Braidwood Station, Unit 2
Facility Operating License Number NPF-77
NRC Docket Number 50-457

Subject: Response to Request for Additional Information Regarding the Braidwood Station
Unit 2 Spring 2005 Steam Generator Inspection

**Response to NRC Request for Additional Information Regarding the Braidwood
Station Unit 2 Spring 2005 Steam Generator Inspection**

Figure 3a-1

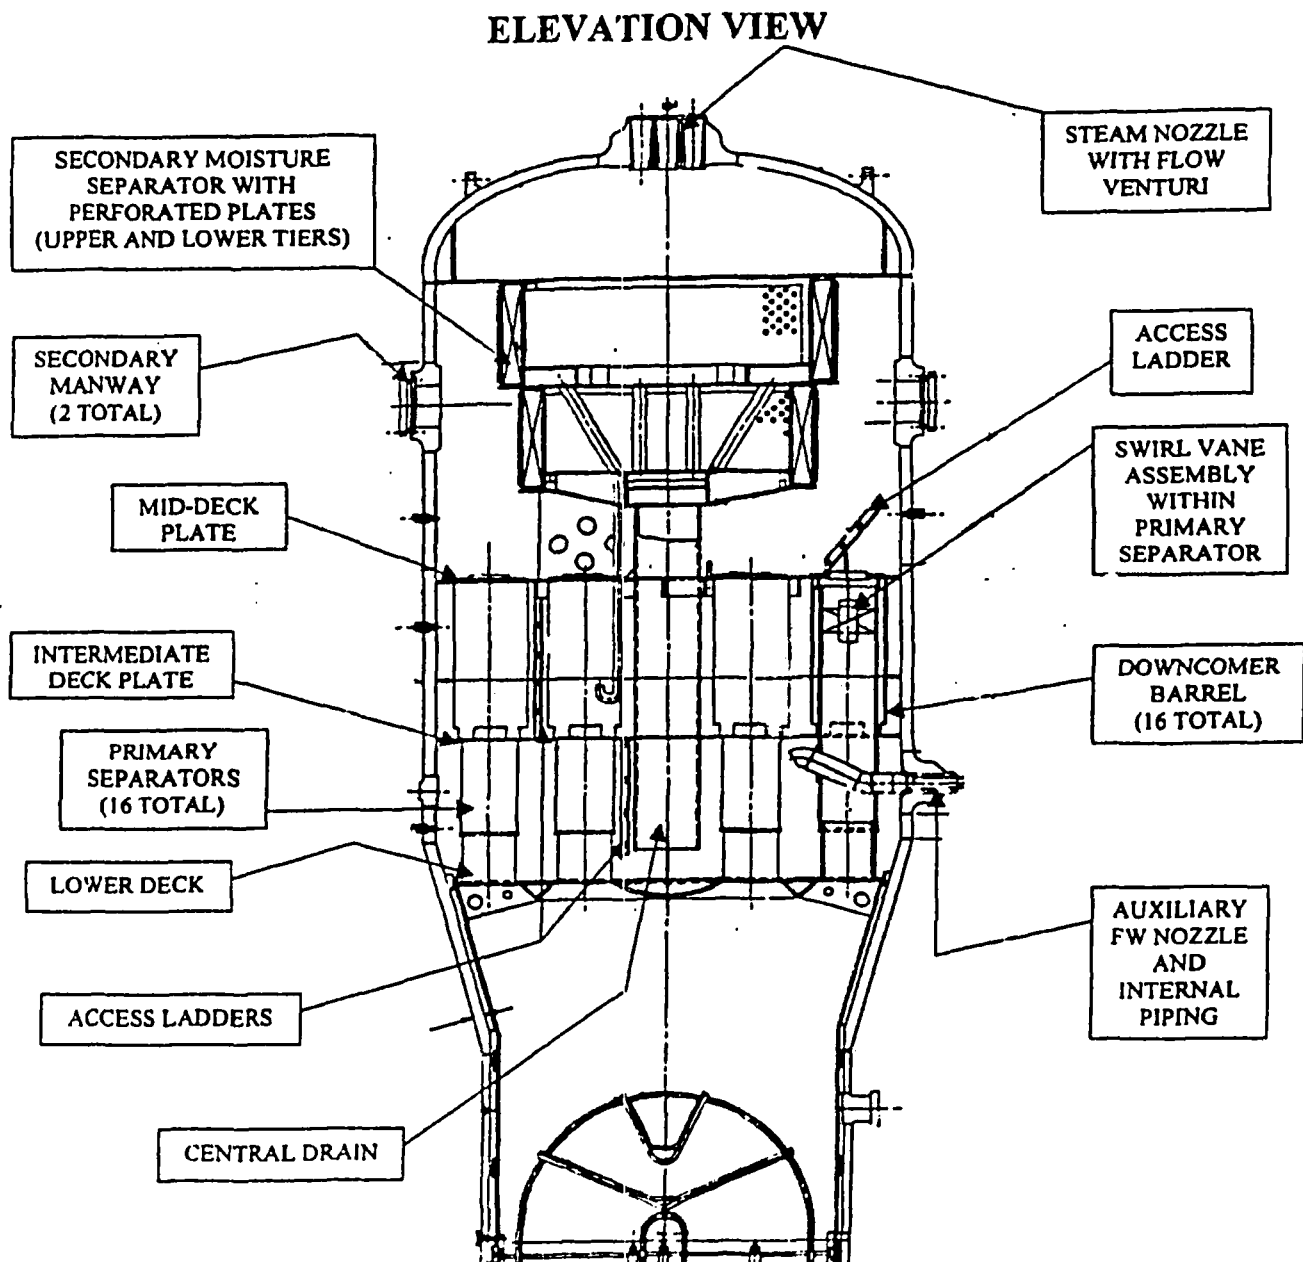
On page 9 of your July 27, 2005, report, you indicated that a visual inspection of the secondary side moisture separator region of steam generator D revealed erosion of the tangential nozzles, downcomer barrels and swirl vanes. In addition, you stated that the erosion in the affected areas was not projected to penetrate through wall over the next operating cycle. With regard to the above, please answer the following questions:

- a. *Provide additional details regarding the areas affected and the extent of degradation.*

During the Braidwood Unit 2 A2R11 refueling outage, visual inspection of the 2D SG secondary side moisture separator region was performed. All areas that are accessible through the upper manways were visually inspected down through the lower deck plate (refer to Figure 3a-1). No degradation, erosion, corrosion, deformation or weld cracking was observed other than the erosion identified in the primary moisture separator region as described below.

During visual inspection of the primary separator assembly region, visual inspection identified that there were areas where the normally present magnetite layer was missing, thus providing areas for erosion to develop. The areas included portions of the tangential nozzles, portions of the inner surface of the primary moisture separator barrels and a number of swirl vanes within the primary separator assemblies (refer to Figure 3a-2). This condition existed in varying degrees on 12 of the 16 primary separators assemblies. The components identified with the magnetite layer missing are carbon steel, typically American Society for Testing and Materials standard specification A-285, "Pressure Vessel Plates, Carbon Steel, Low and Intermediate-Tensile Strength," Grade C, material. The manufacturing nominal wall thickness for these components was 0.250-inch. To supplement the visual inspection observations, ultrasonic (UT) thickness measurements were taken in areas of magnetite loss with most apparent erosion.

Two of the tangential nozzles with the most apparent erosion were UT inspected. The minimum thickness reading for the horizontal region of the tangential nozzles was 0.234-inch. The minimum thickness reading for the vertical region of the tangential nozzles was 0.177-inch.

Three of the riser barrels with the most apparent erosion were UT inspected. The minimum thickness reading was 0.183-inch.

Three of the swirl vanes with the most apparent erosion were UT inspected. The minimum thickness reading was 0.184-inch.

In summary, the overall nominal thickness value for the primary separators assemblies is 0.250-inch with a minimum UT thickness reading for the components inspected of 0.177-inch. No areas of through wall erosion were identified.
